REMARKS

The Examiner's requirement for election/restriction is noted. Applicant's attorney spoke with the Examiner on March 11, 2005 and subsequently filed an Amendment (Election/Restriction) on March 25, 2005 electing with traverse Invention I, the specie represented by Figure 13, deeming that Claims 1-11 read on the elected species. Such election is reiterated herein along with the arguments previously presented.

FIG 19

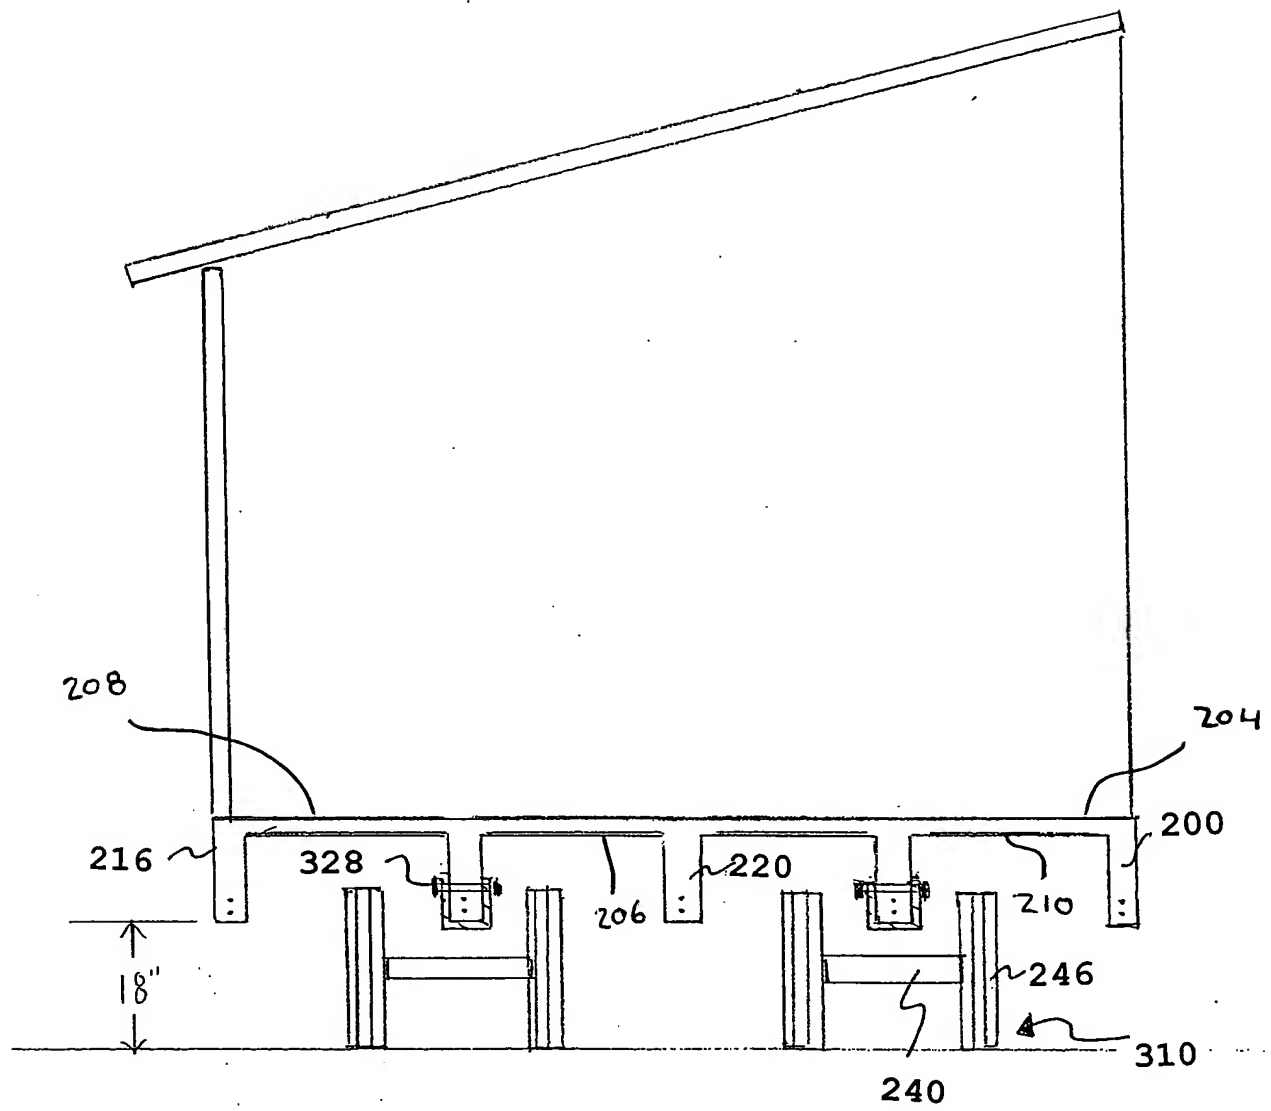
The Examiner has rejected Claims 1-11 under 35 U.S.C. 112 as being indefinite for failing to particularly point out and distinctly claim the subject matter which applicant regards as the invention. These rejections are traversed in view of the amendments herein. More specifically, such corrections include, in claim 1, line 20 language relating to the "peripheral edges", line 21 language relating to "front and rear edges", lines 29-30 language relating to "multi-stemmed concrete floor system". Such corrections also include claim 2, line 26 language relating to "adjustable eave roof ridge connector and eave connectors". Lastly, the Examiner asserts that the means that the system is "self-trailing" is not adequately defined. Text has been added to the specification to clarify the components that make the system "self-trailing" which include the wheel 246 and there coupling assembly shown in Figure 19 as well as the coupler 264 and king pin 266 shown in Figure 31.

Eubanks teaches a concrete slab that does not have a forward and rearward edge, but only has two side edges. The side edges (#23, Fig 1) do not provide any front to rear rigidity as they only meet with side to side reinforcement members. Contrast that Eubanks with Figure 19 of the current application. It can be readily seen that in the present invention there are many lengthwise reinforcements that provide much greater resistance to flex during transport, and hence, eliminates cracking. Eubanks lacks, as does Davie, the teaching of a diaphragm header. Eubanks teaches a side edge, but no front and rear edge.

FIG 28

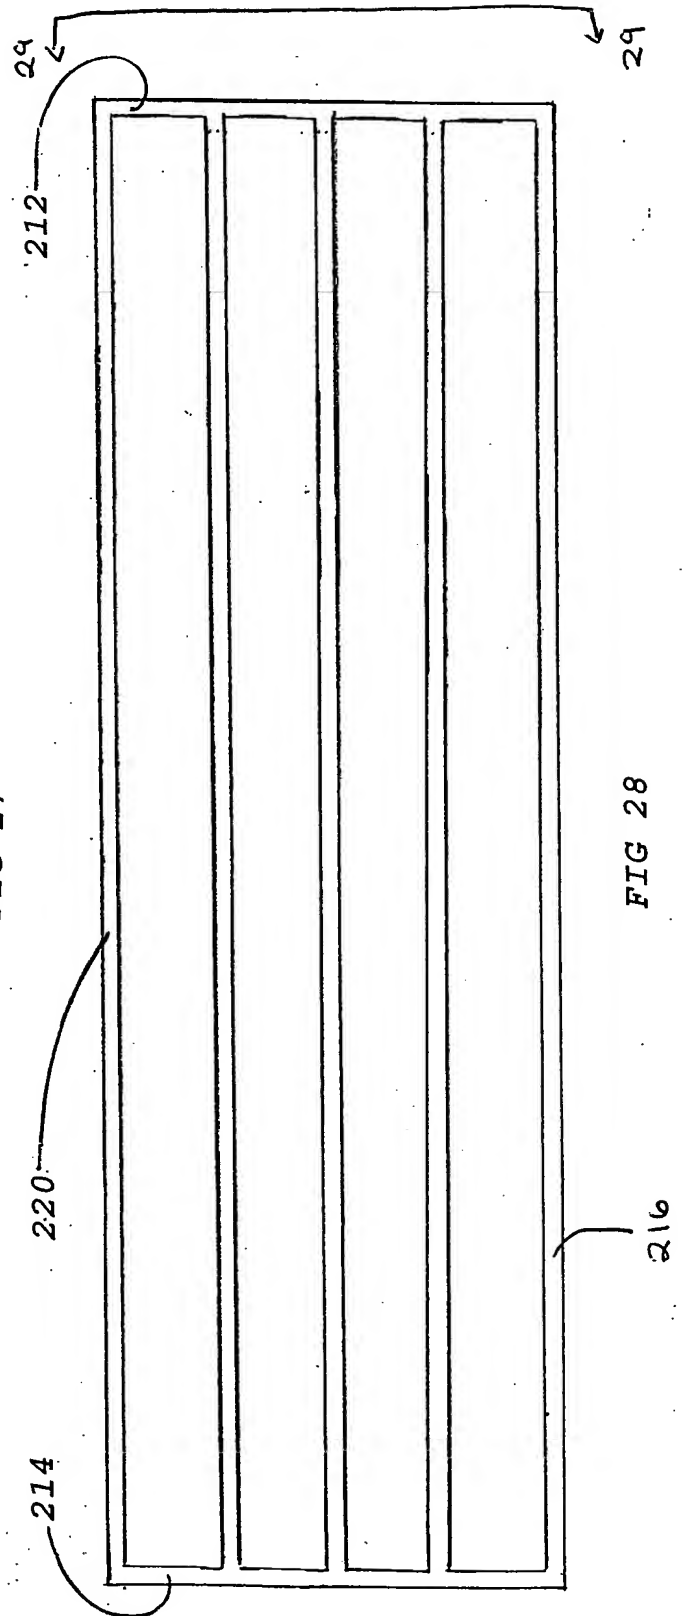
The Examiner's objections to the drawings are noted. In response thereto, appropriate additions have been made to the attached drawings in red for the Examiner's approval to bring the drawings in accord with the specification as filed. New formal drawings are submitted herewith for the Examiner's approval. These changes include the numbering of circle 15 in Figure 13; three additional lines, 19-19, 20-20 and 21-21, to indicate view direction in Figure 18; four additional reference numerals, 204, 206, 208 and 210, in Figure 19; section line 23 in Figure 22A; five additional reference numerals, 224, 228, 230, 234 and 236, in Figure 23; two additional reference numerals, 216 and 224, and a direction line 26-26 in Figure 25; and one additional reference numeral 216 and a direction line 29-29 in Figure 28.
